Access Compliance Report

Public Rights-of-Way

(Curb Ramps)

Intersection ID: 11771	Main Street: SHAMROCK_DR	Cross Street: WINEDALE_LN	Location: S
ADA ID: E9EA08DE45E4	Ramp Type: PerpDiag	Initial Pass/Fail: Fail	Overall Compliance: No
Codes/Mitigation Info/Possible Solution		Field Measurements/Component Compliance	
Severity Score: 33.75

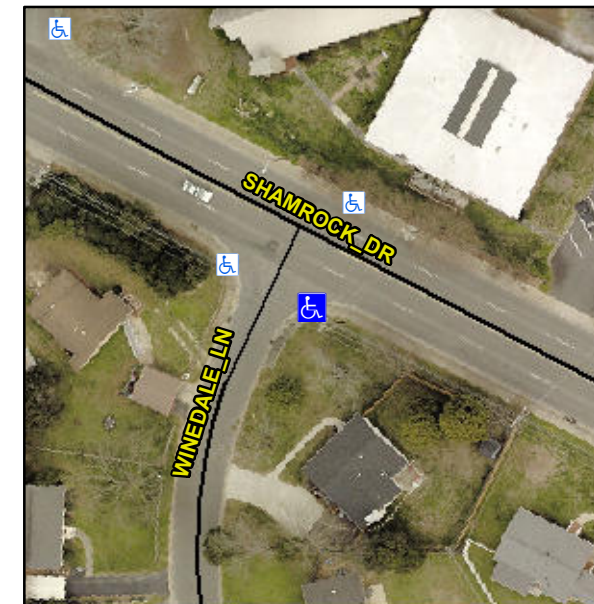
Remove & Replace Curb Ramp With Two New Directional Ramps or Equivalent.

Not Found, R304.5.1, R304.2.2

Compliance	Description	Data	Compliance	Description	Data
N/A	Ramp Length (in)	60.0	No	Ramp Slope (%)	12.5
No	Ramp Width (in)	38.0	Yes	Ramp XSlope (%)	0.8
N/A	Flare Type LT	N/A	N/A	Flare Type RT	N/A
N/A	Flare Slope LT (%)	N/A	N/A	Flare Slope RT (%)	N/A
N/A	Flare Traversable LT?	N/A	N/A	Flare Traversable RT?	N/A
N/A	Landing Length (in)	N/A	N/A	DWS Provided?	N/A
N/A	Landing Width (in)	N/A	N/A	DWS Contrast?	N/A
N/A	Landing Slope (%)	N/A	N/A	DWS Length (in)	N/A
N/A	Landing X Slope (%)	N/A	N/A	DWS Full Width?	N/A
N/A	Landing Curb? (Y/N)	N/A	N/A	DWS Offset (in)	N/A
N/A	Shared Landing?	N/A			
N/A	Gutter Ponding?	N/A	N/A	Gutter Slope (%)	N/A
N/A	Gutter Lip Ht (in)	N/A	N/A	Gutter X Slope (%)	N/A
N/A	Painted X Walk1?	No	N/A	Painted X Walk2?	No
	X Walk 1 Direction	To NE		X Walk 2 Direction	To NW
N/A	X Walk 1 Width (in)	N/A	N/A	X Walk 2 Width (in)	N/A
	X Walk 1 Slope (%)	2.1		X Walk 2 Slope (%)	1.0
	X Walk 1 X Slope (%)	0.7		X Walk 2 X Slope (%)	0.7
